Transportation & Infrastructure Subcommittee

SR 211 Resurfacing Public Meeting Briefing

Briefing From the Public Meeting

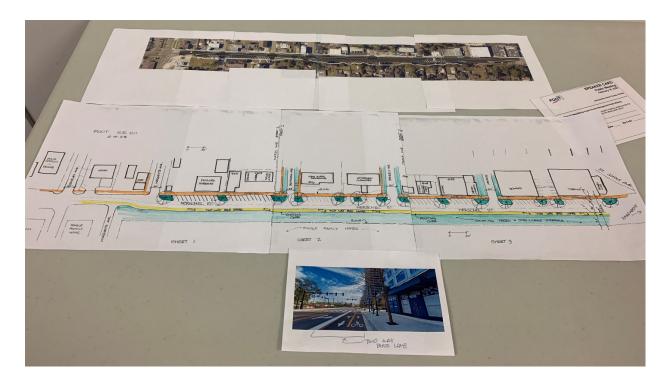
- Removal of parking needs to be more surgical and based on crash data instead of wholesale removal based on site distance requirements from intersections and driveways.
- On-street parking helps with speed reduction and improves the walkability of the neighborhood.
- Better integrating crosswalks at areas where we know there is high usage including the installation of rapid flashing beacons or raised crosswalks at key areas like St. Vincent's, Publix, and RAM.
- A road diet with a median near RAM to help with pedestrian crossings by providing a shelter midway across the road such as the one in front of the Cummer Museum. Peninsular Place does not warrant such a long dedicated left turn only, if any, for its use. This left turn only lane should be a raised median.

A Riverside Ave Drainage Study from Osceola to Stockton is part of the City of Jacksonville CIP as
a separate project already. Will there be any coordination with the city regarding drainage
improvements along this project corridor that could be addressed sooner as part of this project?
 The most contentious issue of the evening was with regards to the removal of street parking, most
notably between Edgewood Ave to King Street where 62 parking spaces have been identified to be
removed. The overwhelming majority of public commenters were in favor of keeping the existing street
